DOCUMENT CHANGE REQUEST

DCR number 423	Changes required for: N/A	Originator: aissa nehdi
Date: 2008/07/24	Date sent: 2008/07/24	Organisation: CNES
Status: IMPLEMENTED

Title:	Transistors Low Power NPN, based on type 2N2484		
Number:	5201/001	Issue:	3

1.6.3 Chip Carrier Package (CCP) - 3 terminal

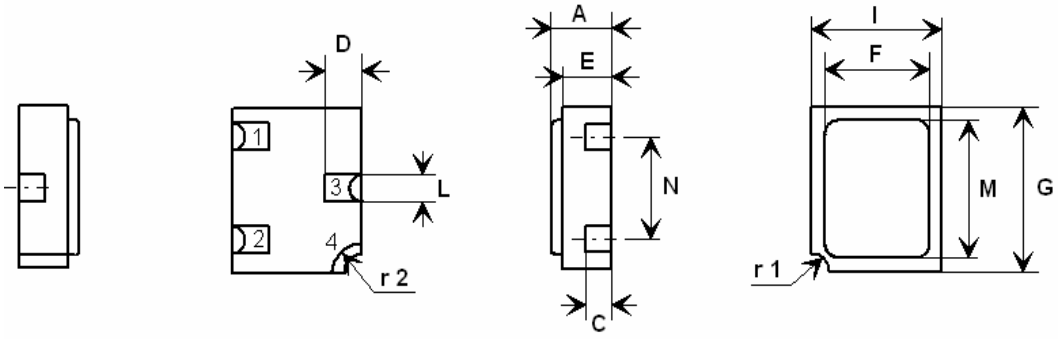
Variants 6 & 7 added (Chip Carrier Package CCP) 3 terminal

Variant Number	Based on Type	Case	Lead/Terminal Material and finish	Weight max g
01	2N3700	**TO-18**	**D2**	**0.4**
02	2N3700	**TO-18**	**D3 or D4**	**0.4**
04	2N3700	**CCP**	**2**	**0.06**
05	2N3700	**CCP**	**4**	**0.06**
06	2N3700	**CCP**	**2**	**0.06**
07	2N3700	**CCP**	**4**	**0.06**

Symbols	Dimensions mm		Notes
	Min	Max	
A	1.15	1.5	
C	0.45	0.56	2
D	0.6	0.91	2
E	0.91	1.12	
F	1.9	2.15	
G	2.9	3.25	
I	2.4	2.85	
L	0.4	0.6	2
M	2.4	2.65	
N	1.8	2	
r1	0.3 TYPICAL		1
r2	0.56 TYPICAL

1. Terminal identification is specified by reference to the corner notch position where terminal 1 = emitter, terminal 2 = base, terminal 3 = collector, terminal 4 = Shielding connected to the lid.
2. Applies to all terminals.

1.6.3 Chip Carrier Package (CCP) - 3 terminal

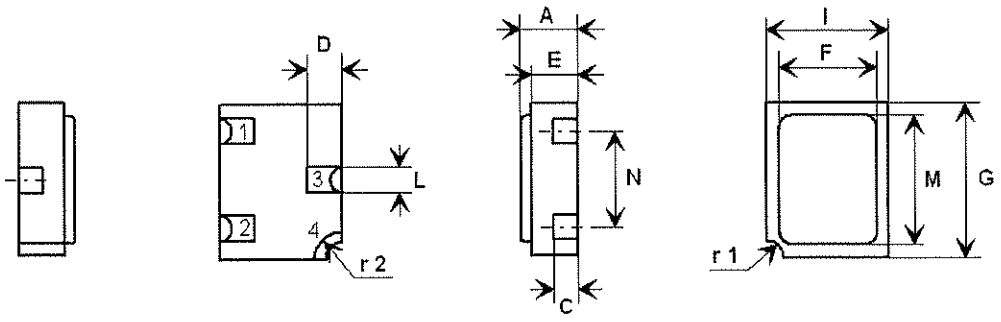
MODIFIED ATTACHMENT FOR DCR 423

SHOWING "APPROVED WORDING" IF DIFFERENT FROM "PROPOSED WORDING":

Variant Number	Based on Type	Case	Lead/Terminal Material and finish	Weight max g
01	2N3700	TO-18	D2	0.4
02	2N3700	TO-18	D3 or D4	0.4
04	2N3700	CCP	2	0.06
05	2N3700	CCP	4	0.06
06	2N3700	CCP	2	0.06
07	2N3700	CCP	4	0.06

(4Terminal)

(3Terminal)

Note: Based on Type number as per applicable Detail Spec i.e.:
2N3700, 2N2907A, 2N5401, 2N4033, 2N2369A, 2N2484

Symbols	Dimensions mm		Notes
	Min	Max	
A	1.15	1.5	
C	0.45	0.56	2
D	0.6	0.91	2
E	0.91	1.12	
F	1.9	2.15	
G	2.9	3.25	
I	2.4	2.85	
L	0.4	0.6	2
M	2.4	2.65	
N	1.8	2	
r1	0.3 TYPICAL		1
r2	0.56 TYPICAL		1

1. Terminal identification is specified by reference to the corner notch position where terminal 1 = emitter, terminal 2 = base, terminal 3 = collector, terminal 4 = Shielding connected to the lid.
2. Applies to All terminals, 1, 2, 3 S
